Work Order ID 92225

Item Name: Crosstube Aft

DRAWING NO. D206-667-241	TITLE CROSSTUBE ASS'Y (206B HIGH AFT)	REV. C	DART AEROSPACE LTD ENGINEERING ORDER		D.E.O. NO. D206-667-241-C-1	SHEET NO. SHEET 1 OF 1	SCALE NTS
DRAWN 92	CHECKED AS	MFG. APPR. M	APPROVED [Signature]		DE APPR. [Signature]		
DATE 11.07.15	DATE 11.08.22	DATE 11.08.22	DATE 11/08/22		DATE 11.08.22

**PURPOSE:**

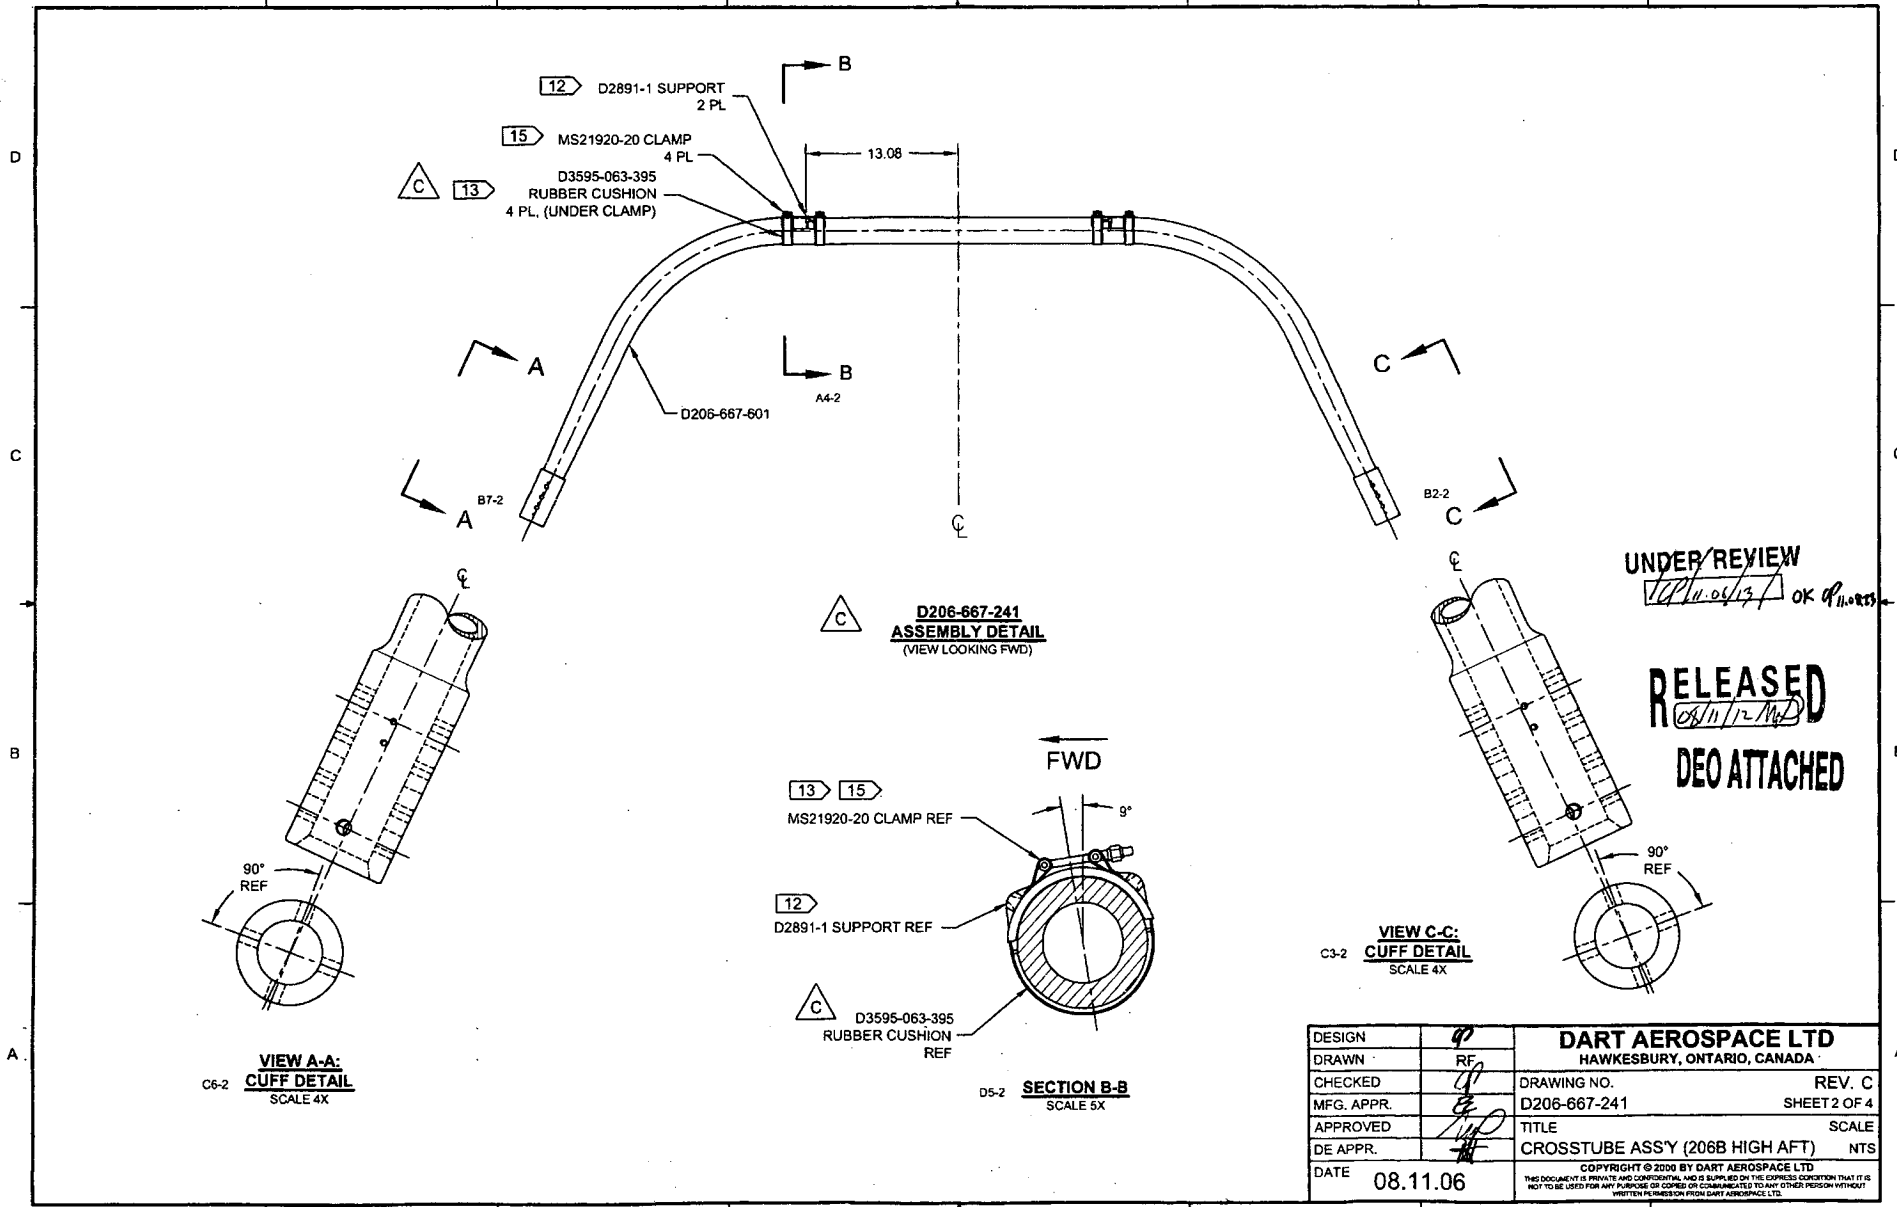
DEO ATTACHED

REPLACE MAGNOBOND WITH PROSEAL.

NOTE 12 & 15, SHEET 1 IS AMENDED AS FOLLOWS:

- 12) TO INSTALL D2891-1 SUPPORT: ABRABE MATING SURFACE OF SUPPORT AND CROSSTUBE WITH 180-GRIT SANDPAPER AND REMOVE RESIDUE WITH MEK (OR EQUIVALENT). APPLY A 0.04" TO 0.07" THICK LAYER OF PROSEAL 890 CLASS B-2 (OR AMS-S-8802 CLASS B-2) SEALANT TO MATING SURFACE OF SUPPORT.
- 15) TORQUE CLAMPS 80 TO 100 IN-LB. ENSURE AT LEAST 1.5 THREADS SHOWING IN SAFETY AND THAT NUT HAS NOT BOTTOMED-OUT AFTER TORQUING. **PRIOR TO PACKAGING, RE-CHECK TORQUE ON CLAMPS AFTER PROSEAL 890 SEALANT HAS CURED FOR 72 HOURS.**
